5 COMMENTS AND RESPONSES

In addition, the chapter includes responses to comments received at the public hearing on the Draft EIR, which was held on February 25, 2010. An official transcript of the public hearing is reproduced following the public comment letters.

Re: Notice of Availability of a Draft Environmental Impact Report – Seismic Phase 2 Project,
Lawrence Berkeley National Laboratory

FIGURE 4.5-2
GEOLOGIC MAP OF THE EAST CANYON AREA

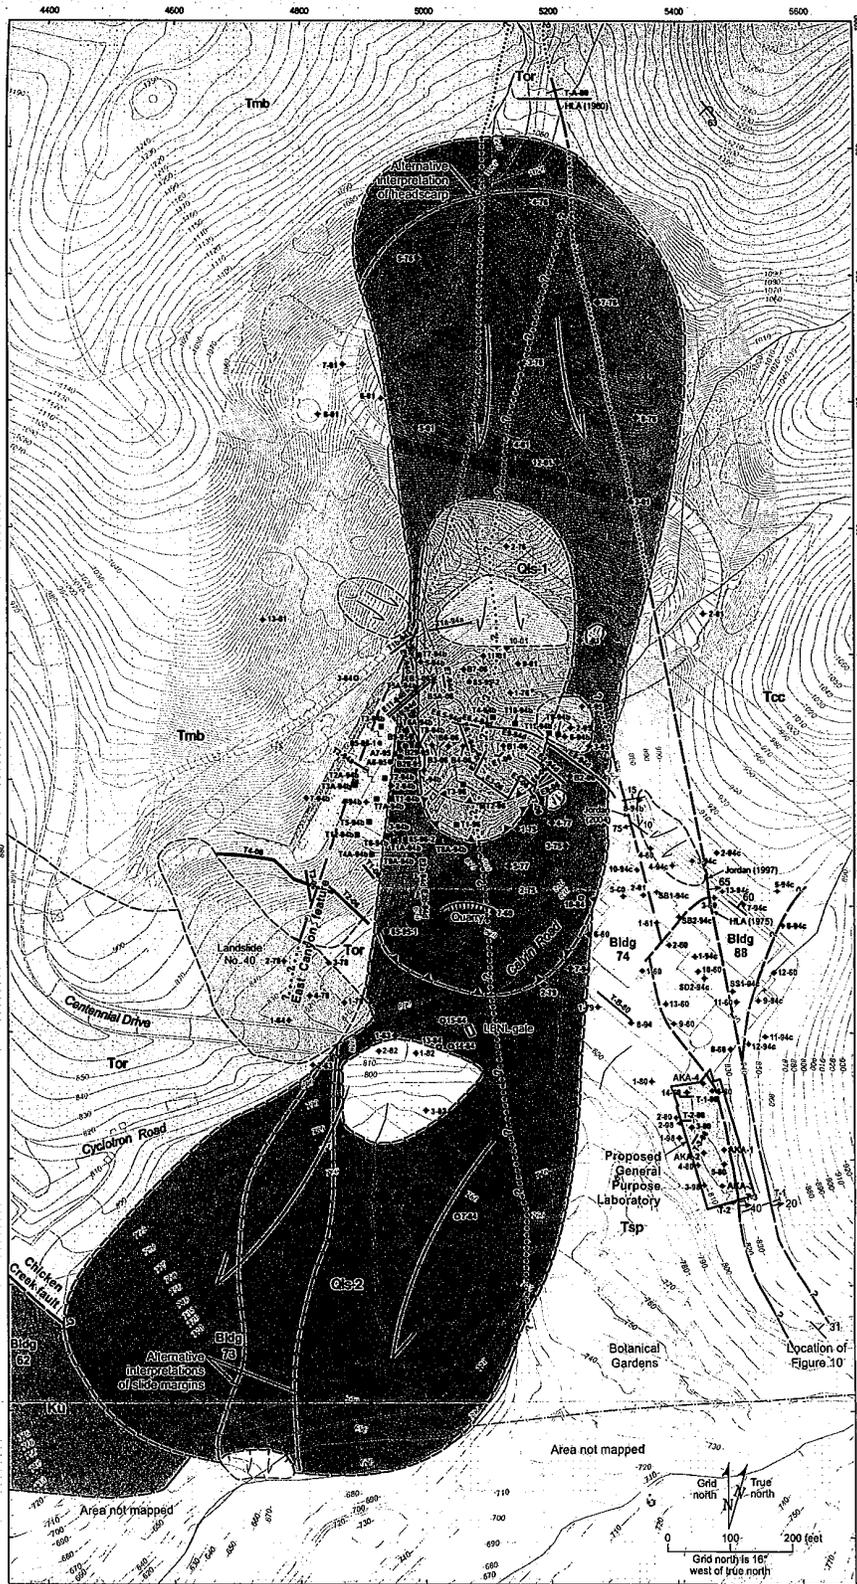
- For example, the Geologic Map of the East Canyon Area (Figure 4.5-2) includes the General Purpose Lab but omits Building 85/85A, which is the Hazardous Waste Handling Facility, the building which is on top of the landslide area and the focus of the seismic mitigation part of the Seismic Phase 2 Project EIR.

SSC-1-10	<p>◆ For example, the Geologic Map of the East Canyon Area (Figure 4.5-2) includes the General Purpose Lab but omits Building 85/85A, which is the Hazardous Waste Handling Facility, the building which is on top of the landslide area and the focus of the seismic mitigation part of the Seismic Phase 2 Project EIR.</p>	<p>The comment is noted. Figure 4.5-2 has been revised to more clearly indicate the location of Building 85/85A. Please see Chapter 3 of the Final EIR.</p>
SSC-1-11	<p>◆ The geotechnical investigations which are conducted are shallow in scope and insufficient to document the geological conditions of the area (see comment letter from Dr. Curtis). It should be noted toward this end that apparently inferior geotechnical studies prepared in 1994 for purposes of constructing Building 85 did not reveal the landslide area later identified in 1996.⁷</p> <p>⁷ Seismic Phase 2 Project DEIR, pages 4.5-11, 12.</p>	<p>The geotechnical studies performed for the construction HWHF were conducted by experienced licensed professionals in accordance with generally-accepted professional procedures and practices and in conformance with the State regulations and guidelines applicable at that time. The State guidelines that pertain to seismically-induced landslides (Special Publication 117) were officially adopted by the State Mining and Geology Board on March 13, 1997. Special Publication 117 provides guidelines for evaluating and mitigating hazards for future projects, as required by the Seismic Hazard Mapping Act. Neither the guidelines nor the Act include retroactive provisions; LBNL is proactively strengthening the HWHF in accordance with the newest State guidelines pertaining to the evaluation and mitigation of potential hazards associated with seismically-induced landsliding (Special Publication 117A, dated 2008). Please see Master Response 1, Geological Conditions Underlying the LBNL Main Hill Site.</p>

FIGURE 2. LBNL SITE MAP, GROUNDWATER CONTAMINATION PLUMES AND CONTAMINATED SOIL SITES.

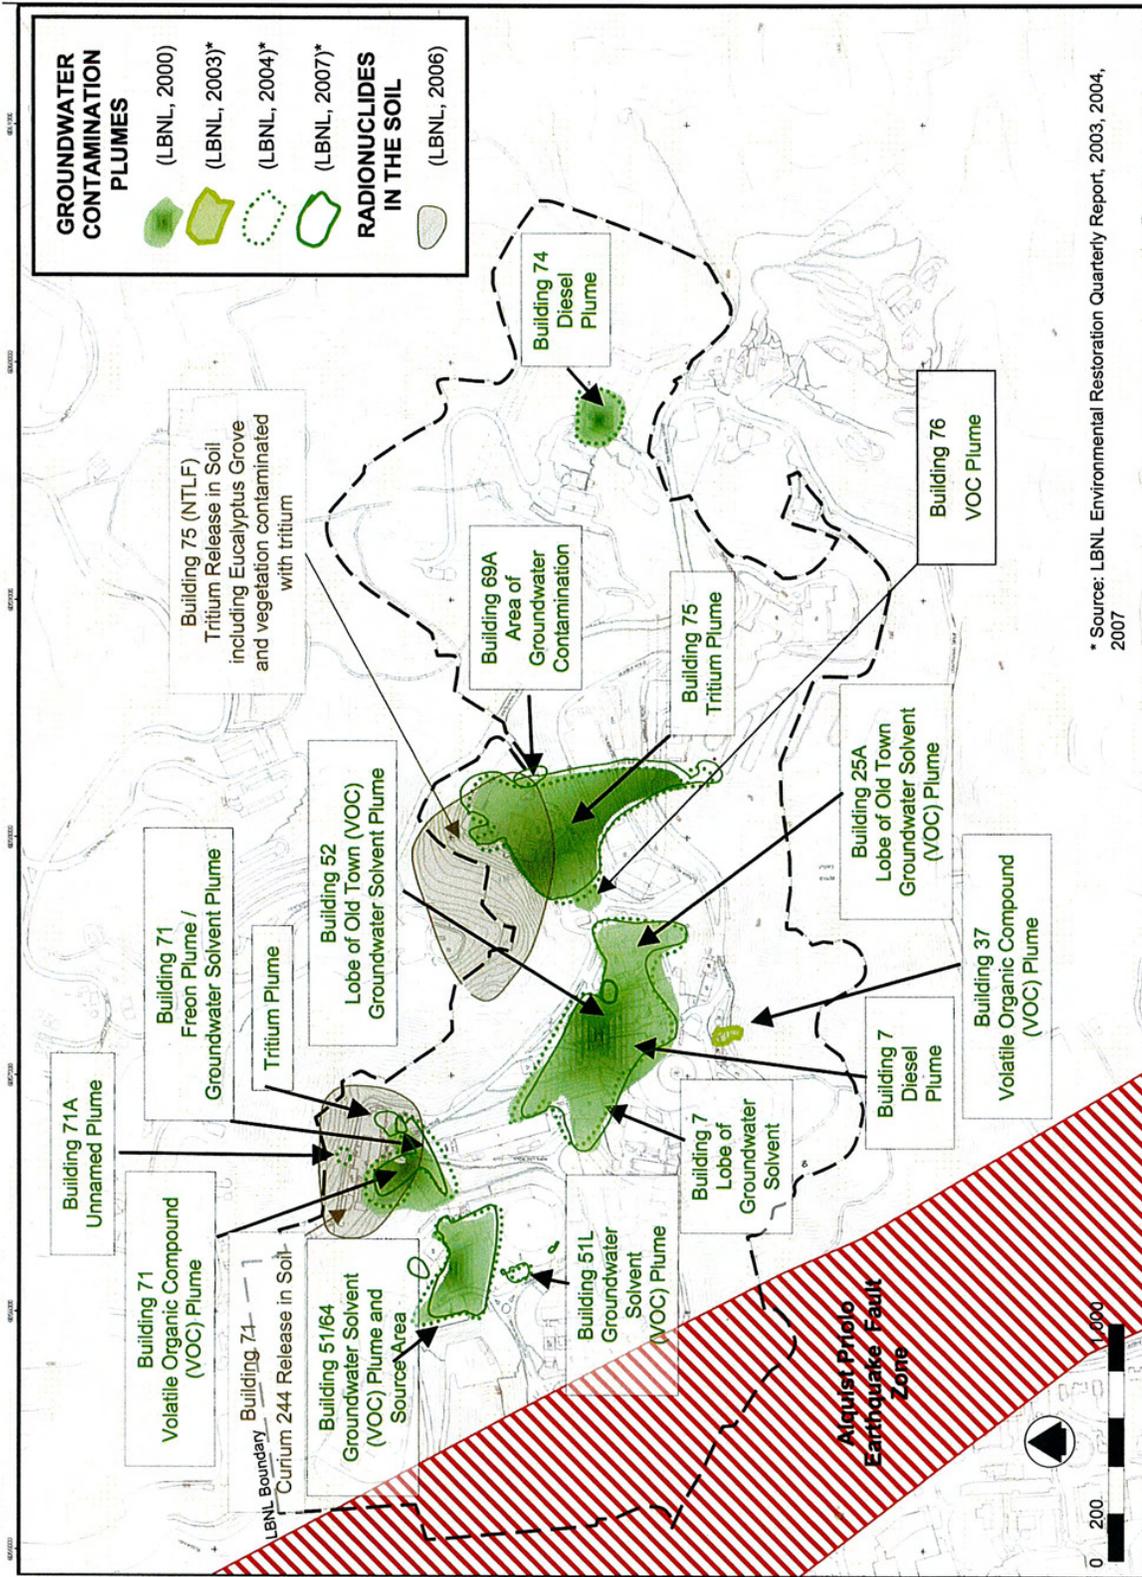
Figure 2. in our Report (page 10) shows a significant VOC (Volatile Organic Compound) groundwater plume associated with B 71 and its "trailer" area, surrounded by a radioactive tritium soil plume.

CMTW-36	Attachment: Figure 2. LBNL Site Map, Groundwater Contamination Plumes and Contaminated Soil Site.	The commenter's materials have been received and reviewed. Because they do not address the adequacy of the EIR, no further response is warranted.
CMTW-37	Attachment: Figure 18a. Zones of Concern for Groundwater Plume Expansion Along Completed Faults, Bedrock Contacts, Landslides, Historic and Modern Creeks.	The commenter's materials have been received and reviewed. Because they do not address the adequacy of the EIR, no further response is warranted.
CMTW-38	Attachment: Figure 10. Compilation of Fault Mapping at LBNL in Strawberry Canyon Relative to Soil and Groundwater Contaminant Plumes.	The commenter's materials have been received and reviewed. Because they do not address the adequacy of the EIR, no further response is warranted.
CMTW-39	Attachment: Figure 14. Compilation of Landslide and Surficial Geology Maps 13a-13f in Strawberry Canyon.	The commenter's materials have been received and reviewed. Because they do not address the adequacy of the EIR, no further response is warranted.

FIGURE 18a. ZONES OF CONCERN FOR GROUNDWATER PLUME EXPANSION ALONG COMPILED FAULTS, BEDROCK CONTACTS, LANDSLIDES, HISTORIC AND MODERN CREEKS. SEE NEXT PAGE FOR MAP LEGEND.

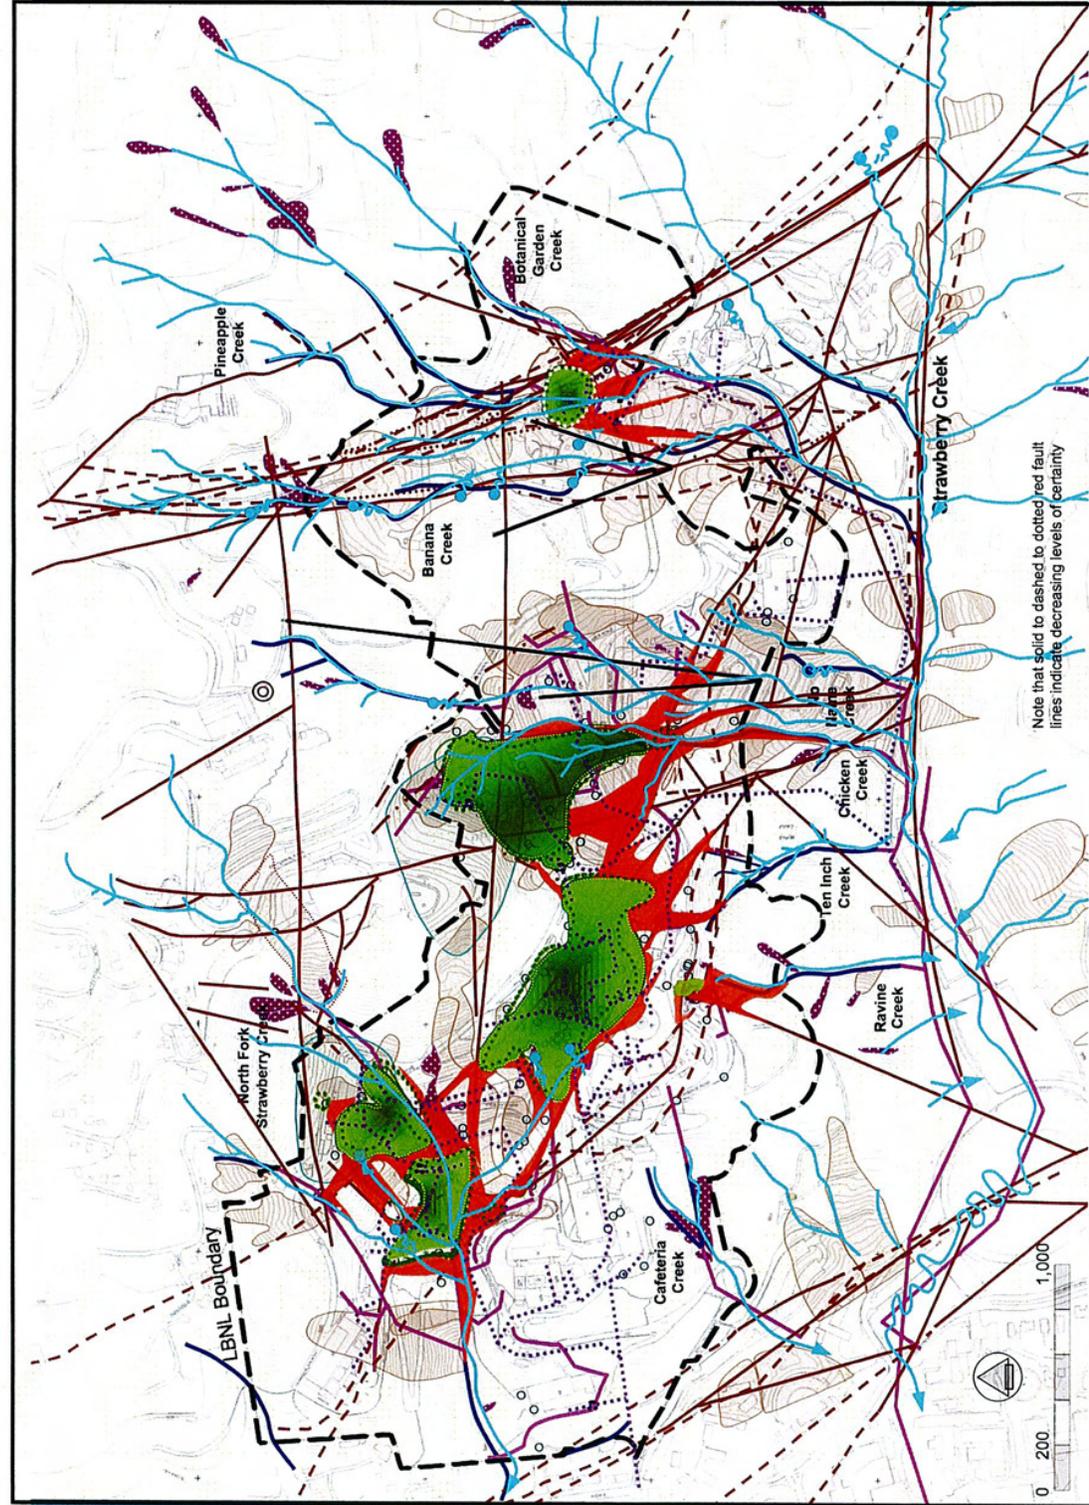
Figure 18 a. shows the Zones of Concern at LBNL for Groundwater Plume Expansion along Faults, Bedrock contacts, Landslides, Historic and Modern Creeks. Please note and address in the EIR/EIS that all 5 areas of the proposed " Seismic Life Safety Phase 2B Project" are impacted by migrating groundwater contaminant plumes, earthquake faults and landslides. (page 11.)

FIGURE 10. COMPILATION OF FAULT MAPPING AT LBNL IN STRAWBERRY CANYON RELATIVE TO SOIL AND GROUNDWATER CONTAMINANT PLUMES.

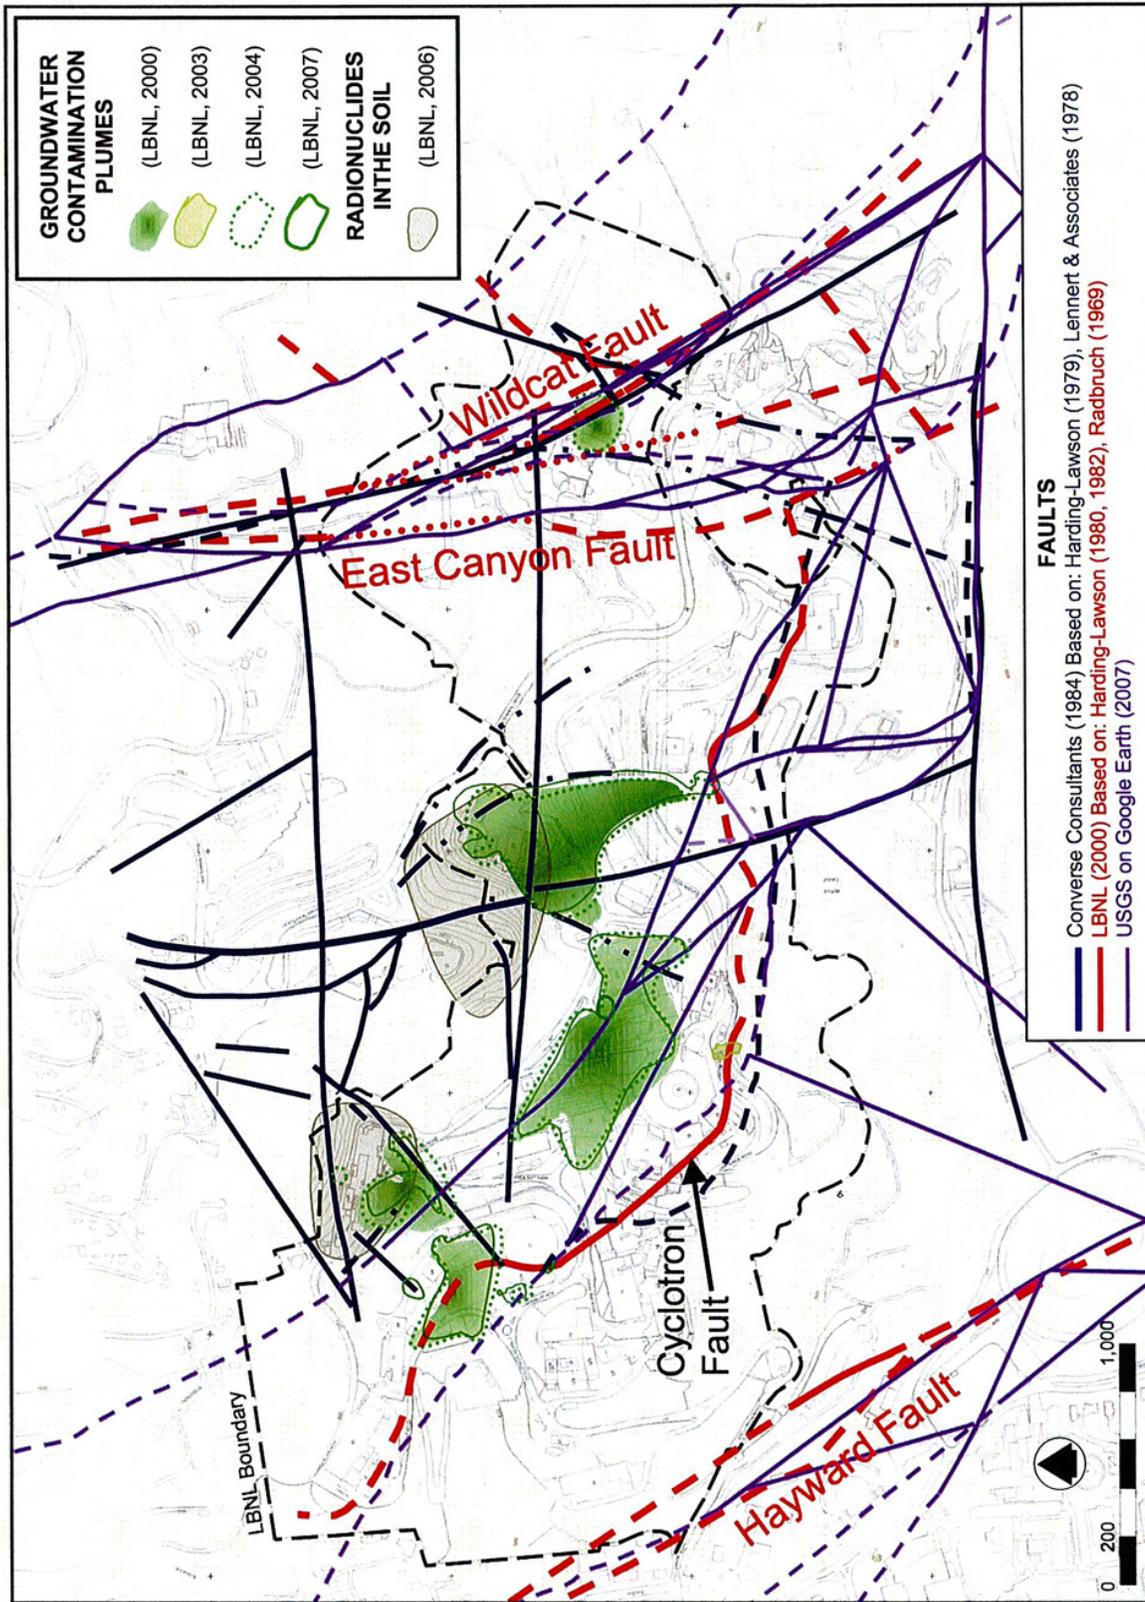
Figures 10 and 14 show the mapping of Wildcat Fault and the East Canyon Fault as well as the huge landslide area associated with these faults. It is quite incredible to observe that indeed LBNL/DOE (Department of Energy) knew of the presence of these earthquake faults and landslide areas, and yet proceeded with the construction of the Lab's Hazardous and Radioactive Waste Handling, Storage and Treatment Facility in this treacherous area in 1996, and now must attempt with seismic upgrades of the building (B 85), and the stabilization of the landslide beneath it. (pages 12-13)

CMTW-32	Figures 10 and 14 show the mapping of Wildcat Fault and the East Canyon Fault as well as the huge landslide area associated with these faults. It is quite incredible to observe that indeed LBNL/DOE (Department of Energy) knew of the presence of these earthquake faults and landslide areas, and yet proceeded with the construction of the Lab's Hazardous and Radioactive Waste Handling, Storage and Treatment Facility in this treacherous area in 1996, and now must attempt with seismic upgrades of the building (B 85), and the stabilization of the landslide beneath it. (pages 12-13)	Please see response to comment PH-13, below. Please see Master Response 1, Geological Conditions Underlying the LBNL Main Hill Site.
CMTW-33	Figure 20 a. (page 14) shows various site conditions at future sites of LBNL's Long Range Development Plan.	The diagram provided by the Commenter is noted. Please see the 2006 Long Range Development Plan EIR for UC LBNL information on constraints and conditions related to the LBNL main hill site as well as to the Illustrative Development Scenario which is depicted on the Commenter's diagram. Please see Master Response 1, Geological Conditions Underlying the LBNL Main Hill Site.

FIGURE 14. COMPILATION OF LANDSLIDE AND SURFICIAL GEOLOGY MAPS 13a-13f IN STRAWBERRY CANYON

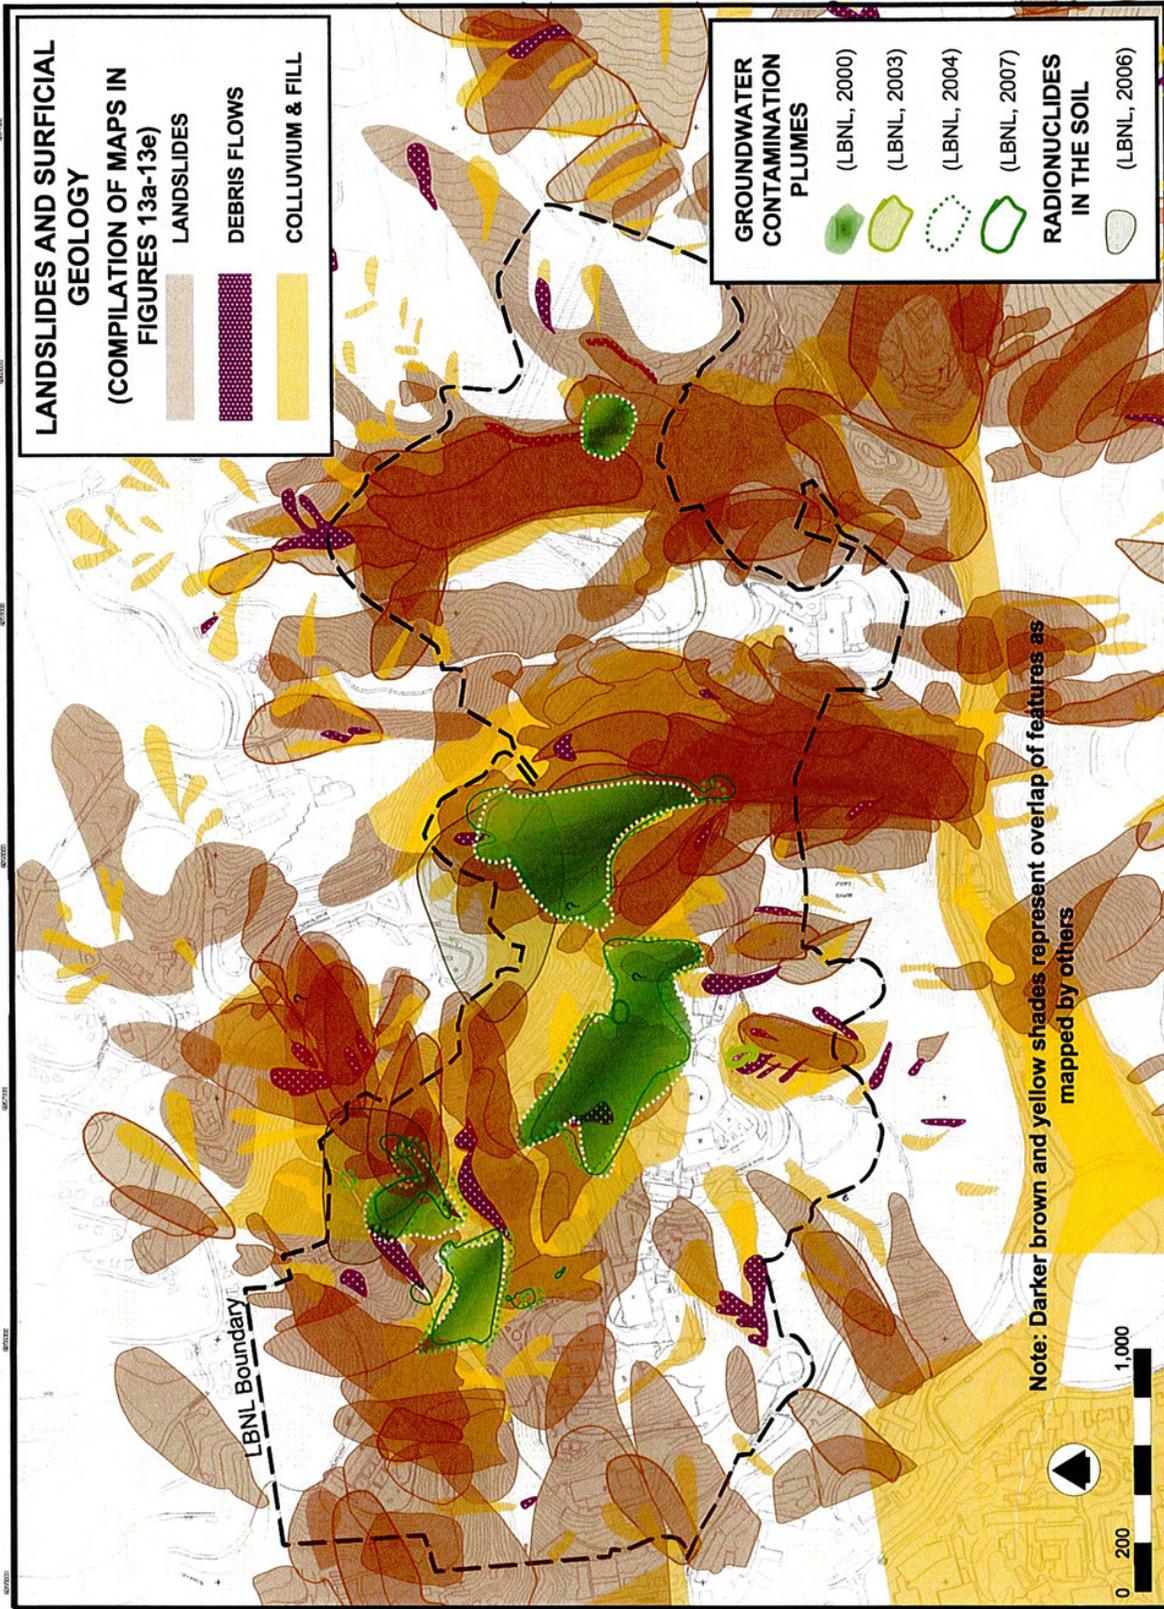
The massive East Canyon Slide (see Figure 14.) extends all the way down to the bottom of Strawberry Canyon and continually undermines the stability of Centennial Drive, the only public (and emergency access) road through the Canyon.
